MFN 08-272

Subject: Response to Portion of NRC Request for Additional Information Letter No. 33 Related to ESBWR Design Certification Application - Containment Systems - RAI Number 6.2-63 S01

**Response to Portion of NRC Request for
Additional Information Letter No. 33
Related to ESBWR Design Certification Application**

RAI Number 6.2-63 S01

Figure 6.2-9e1. Feedwater Line Break (Nominal Case) - Reactor Pressure Vessel Heat Slab Temperatures (2000 S)

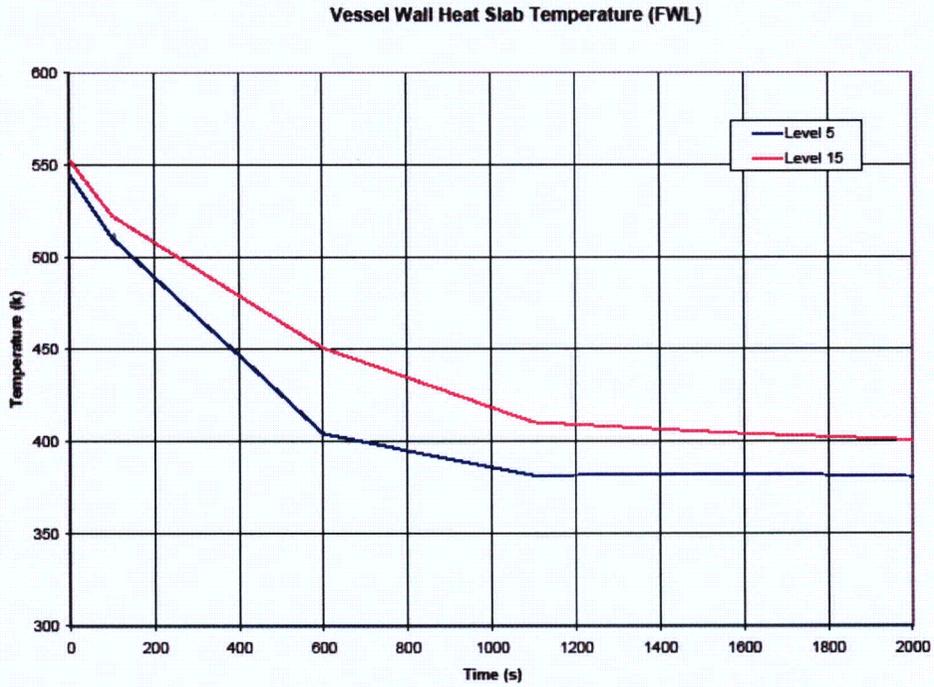
The information provided in this response is necessary to support the basis for a reasonable assurance finding. Thus, please update DCD Tier 2 to include information provided in response to RAI 6.2-63.

The above information was incorporated into the DCD Tier 2, Section 6.2, in Revision 2 as Figures 6.2-9c-series (FWLB) and 6.2-10c-series (MSLB) for the nominal case results, and Figures 6.2-13c-series (FWLB) and 6.2-14c-series (MSLB) for the bounding case results as requested by this RAI. The only change from the RAI response information was that the figures with time zero to 100 seconds period were revised to a time zero to 500 seconds period. These figures have been maintained and updated, as necessary, through the current revision (DCD Tier 2, Revision 4). The reactor pressure vessel (RPV) sensible heat information will be incorporated as a new DCD Tier 2, Table 6.2-12d, and the RPV heat slab temperature profiles will be incorporated into new DCD Tier 2 Figures 6.2-9e1 and 6.2-9e2 for a FWLB, and Figures 6.2-10e1 and 6.2-10e2 for a MSLB.

DCD Tier 2, Subsection 6.2.1.3 will be revised, and Table 6.2-12d and Figures 6.2-9e1, 6.2-9e2, 6.2-10e1, and 6.2-10e2 will be added, as shown in the attached markup.
